MEMORANDUM

To: The Design Advisory Board
From: Mary O'Neil, AICP, Principal Planner
RE: ZP19-0620CA; 9 Lakeview Terrace
Date: April 9, 2019

File: ZP19-0620CA
Location: 9 Lakeview Terrace
Zone: RM **Ward:** 3C
Parking District: Neighborhood
Date application accepted: March 6, 2019
Revised plans received: March 20, 2019, April 1, 2019
1st DAB Review: March 26, 2019
Applicant/ Owner: David DelPiero
Request: Demolish and replace rear (west) addition; change windows in west end, replace vinyl siding with fiber cement board in front, metal in rear. Reconfigure entry to west side of porch, alter south porch roof.

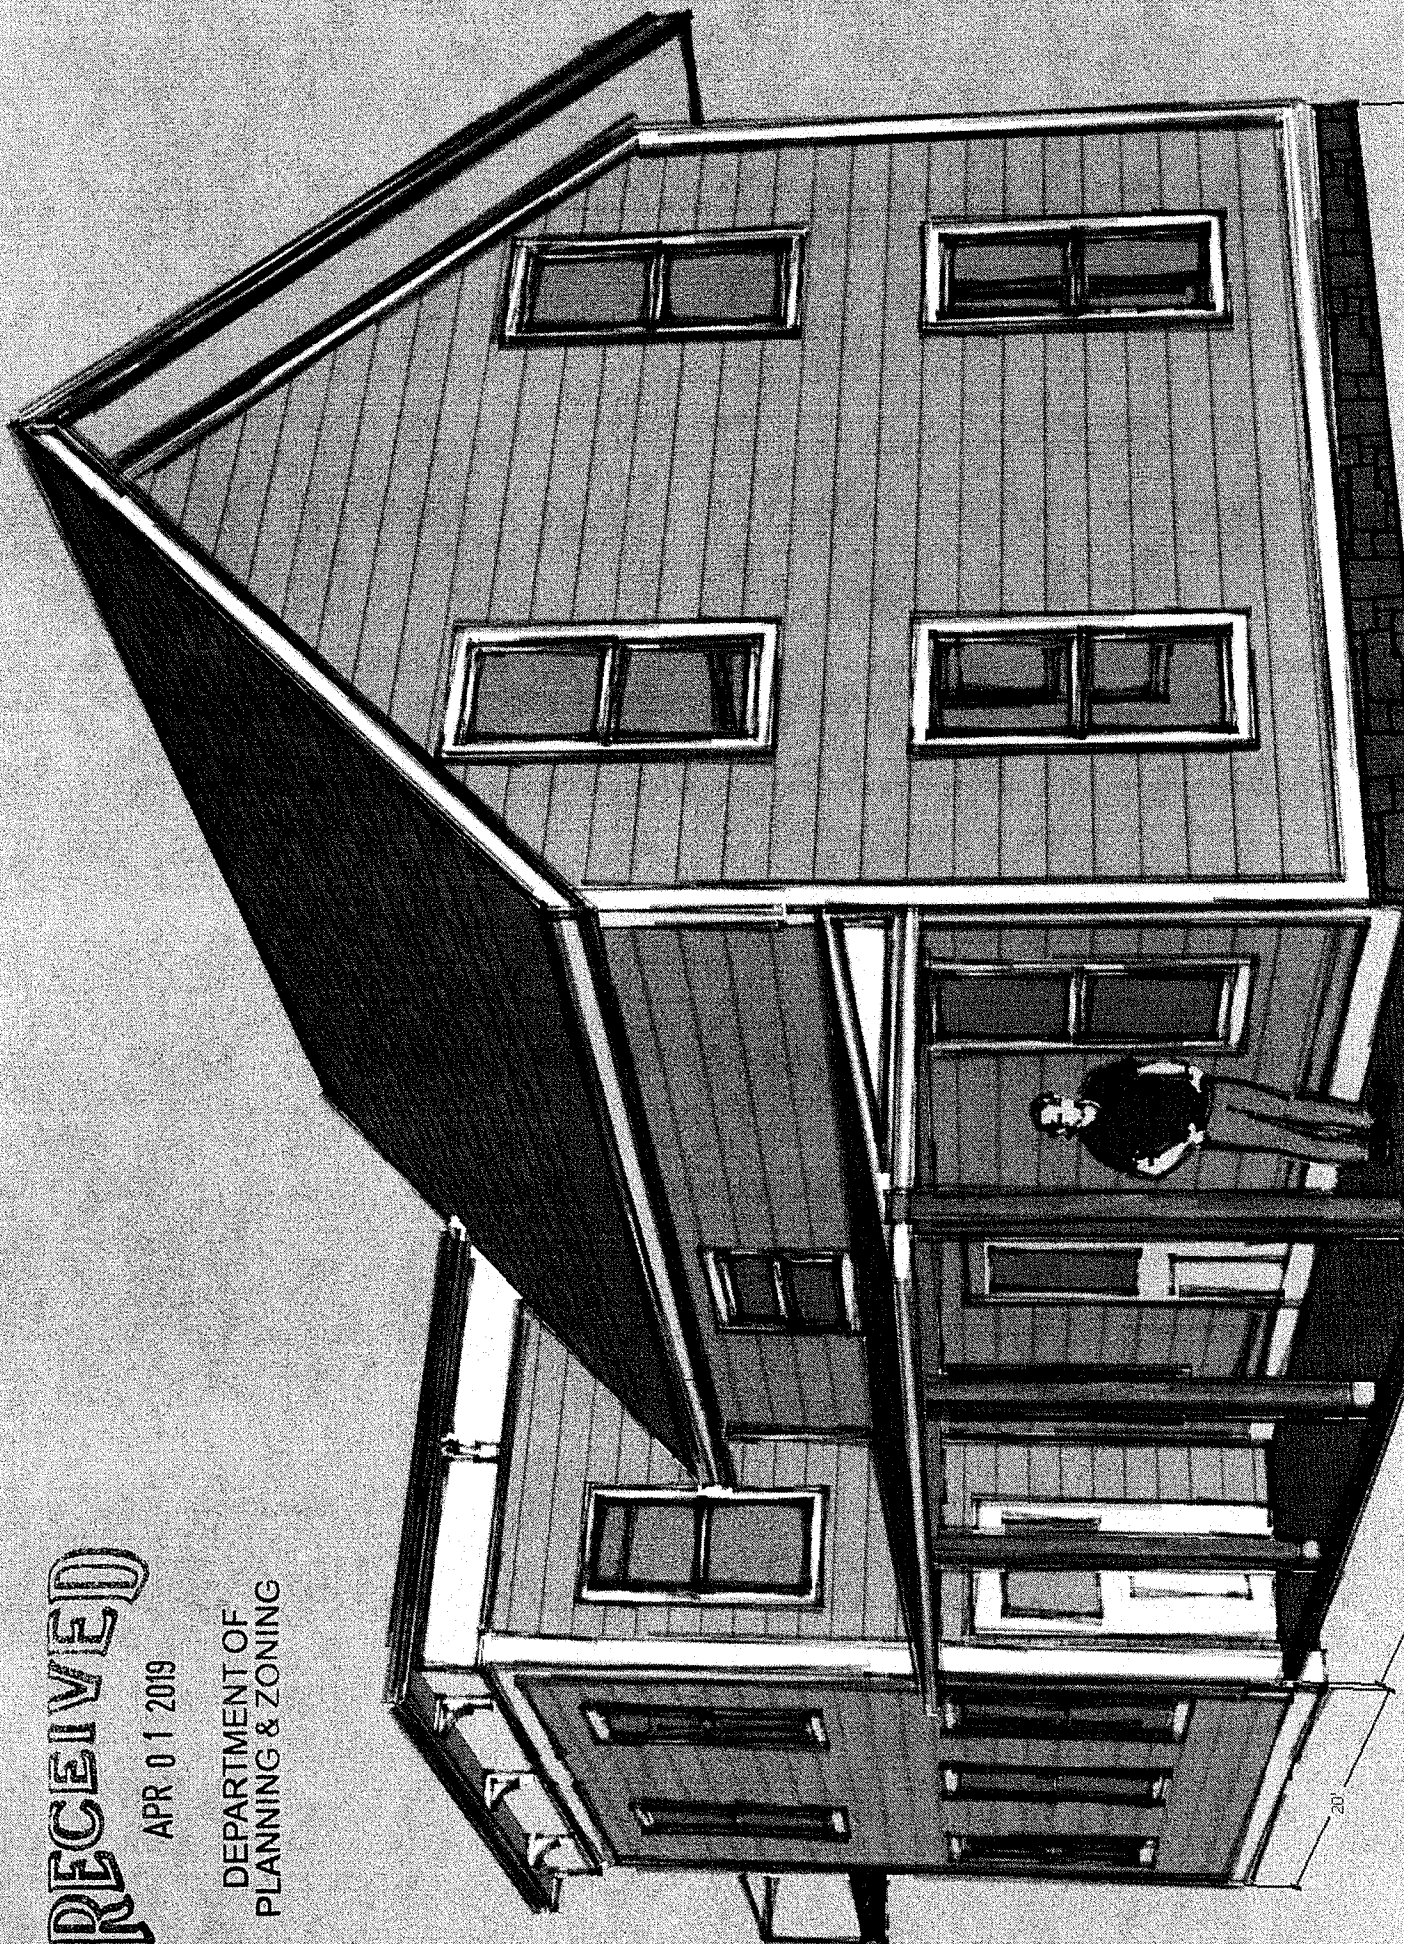
Italianate section) was constructed c. 1900. The third (shed roofed) addition first appears on the 1912 Sanborn Fire Insurance Map. (See inset.)

The proposal will include reconstruction of the westerly most addition **on the same footprint**. The Italianate portion **will remain as existing**. Here is a predictable and easily readable addition to the gable front residence

SOUTH

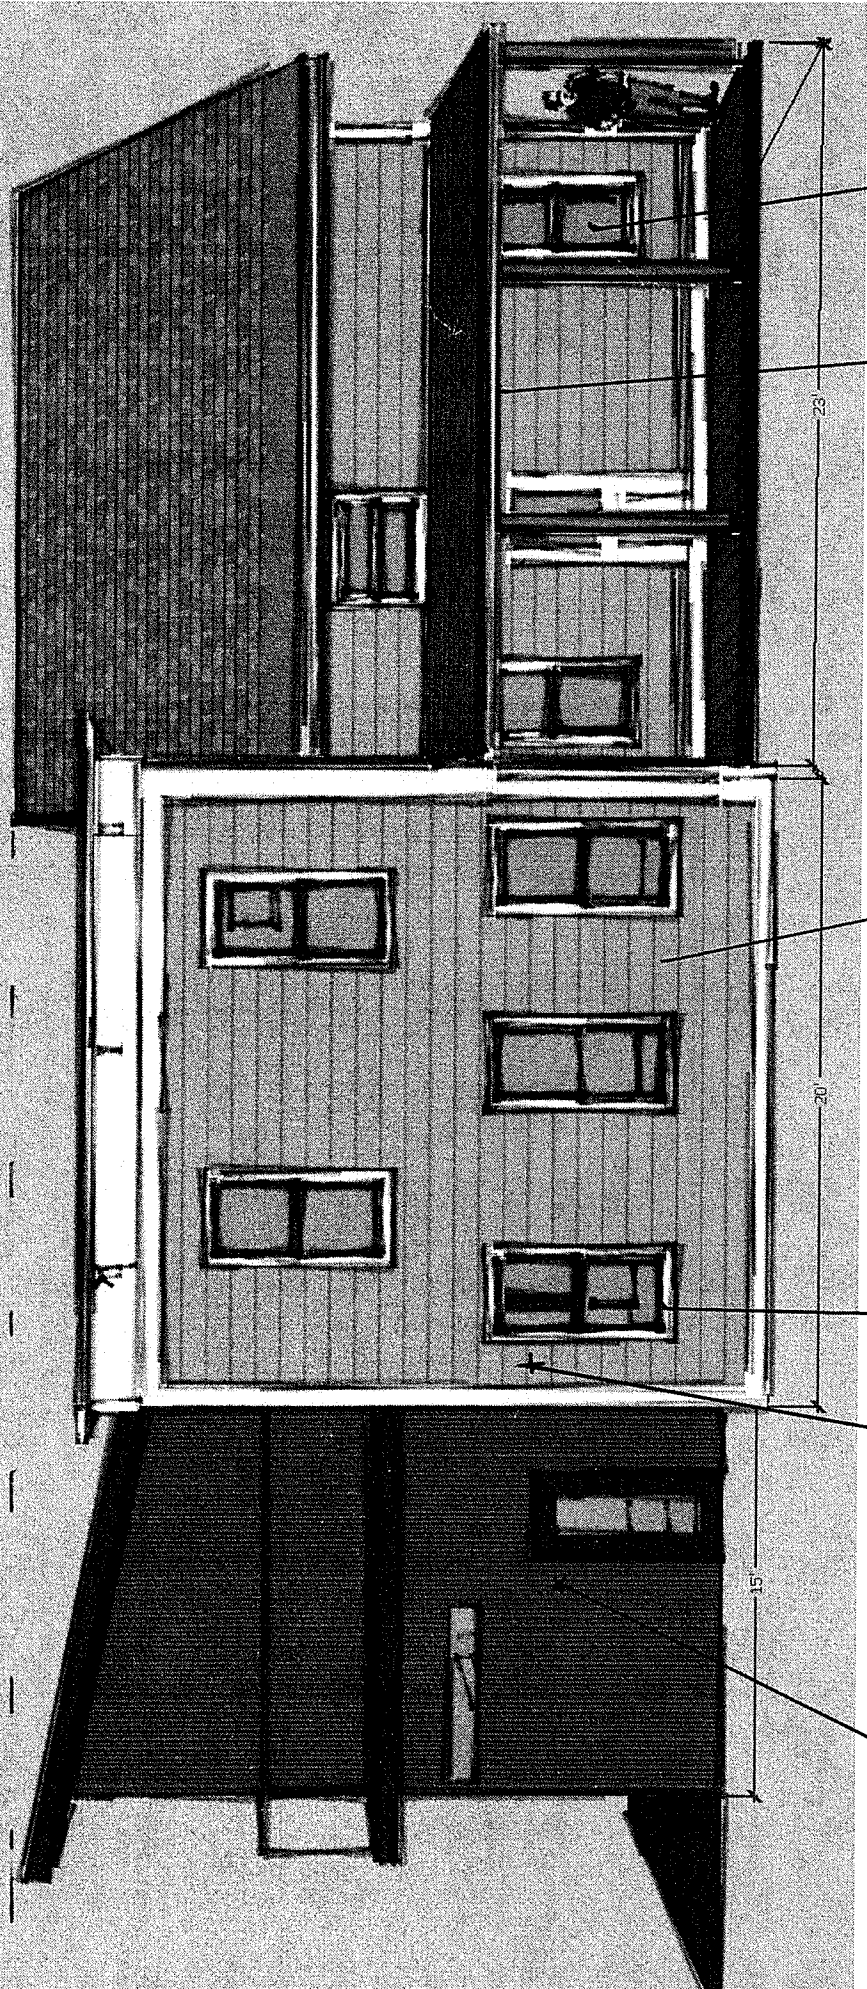
EXISTING DOOR
REPL W/ WINDOW

ENTRY DOOR REMAINS

9 LAKEVIEW SITE PLAN
* NO CHANGES *

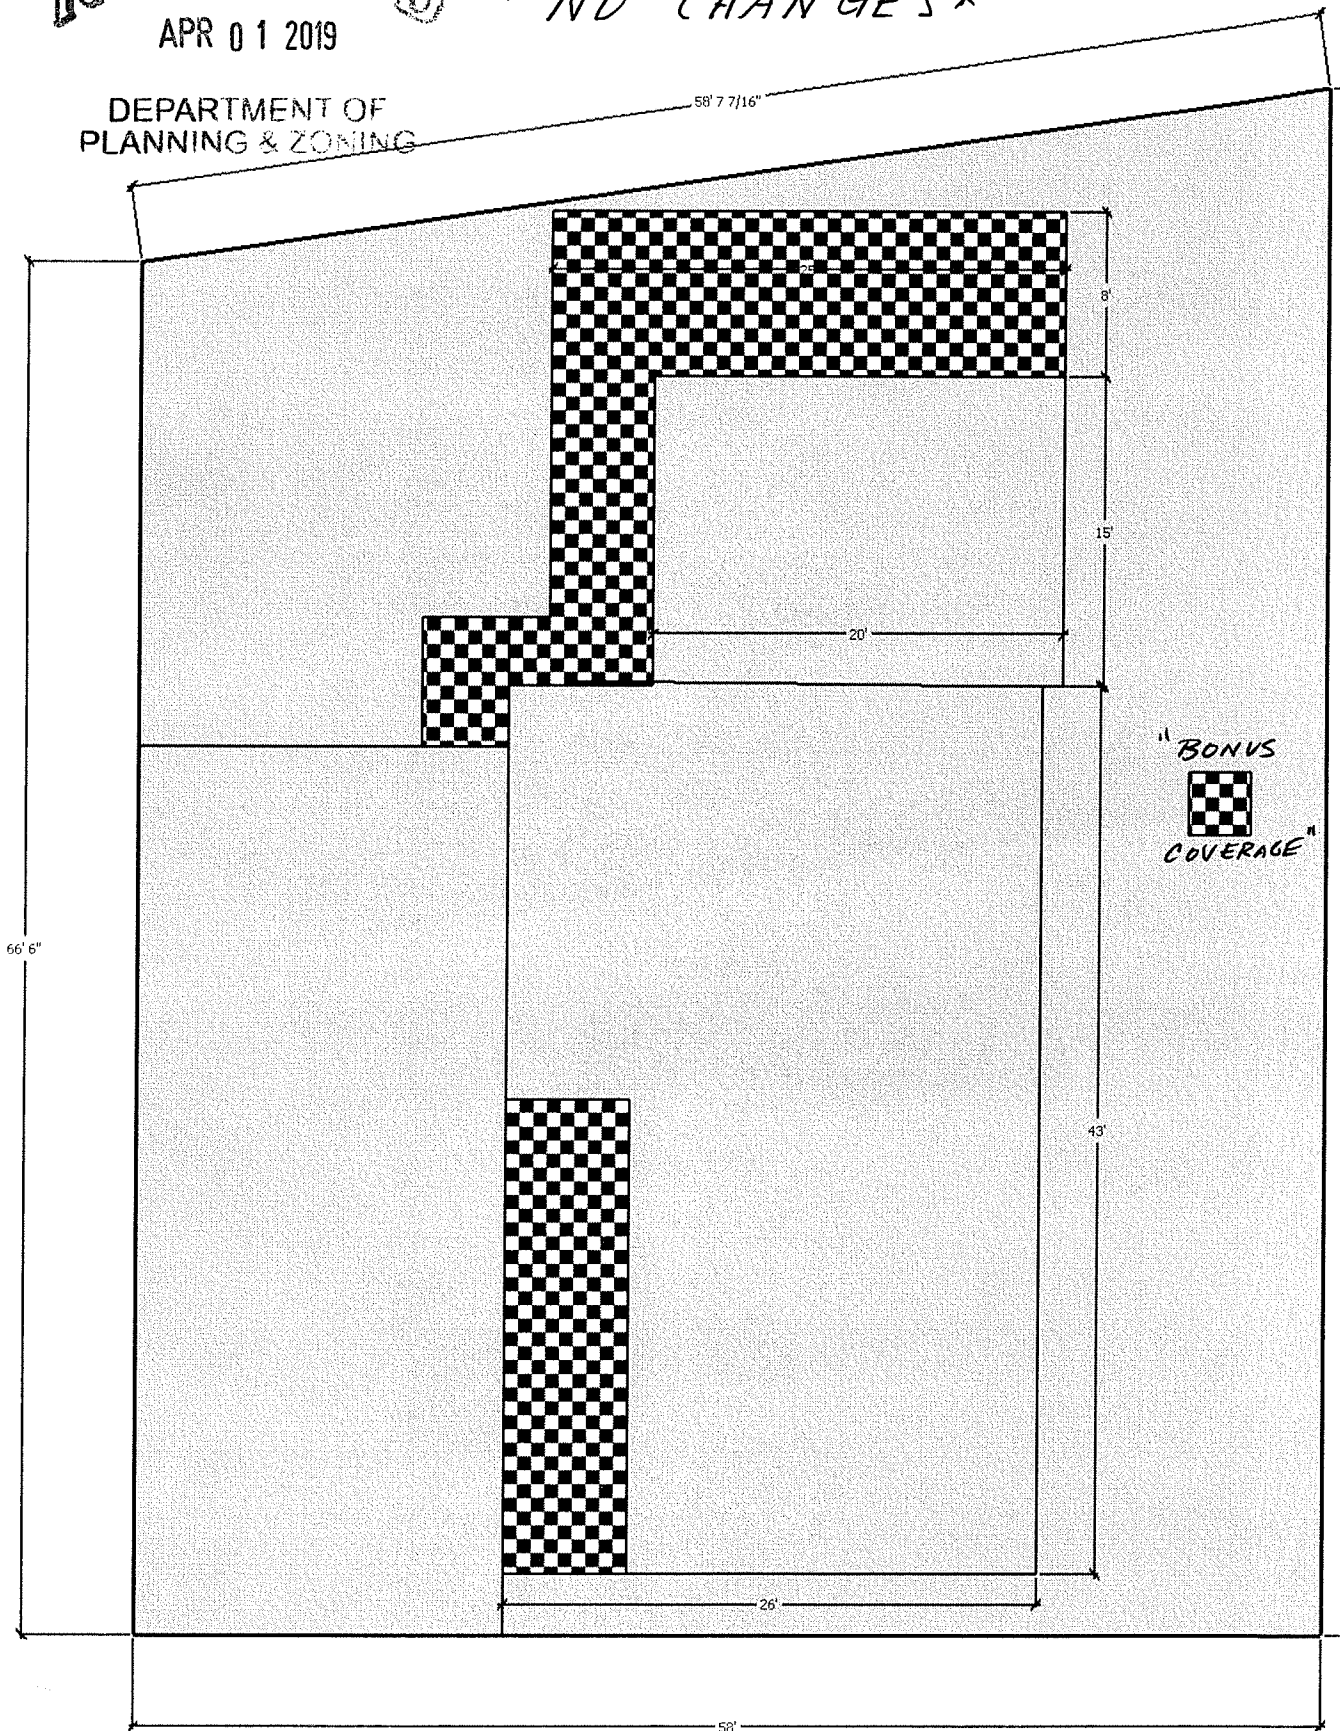
Google images illustrate garbage and recycling receptacles located on the green belt. Assuming this image was NOT taken on trash day, a secure place that prevents blowing trash must be identified and included on the site plan.
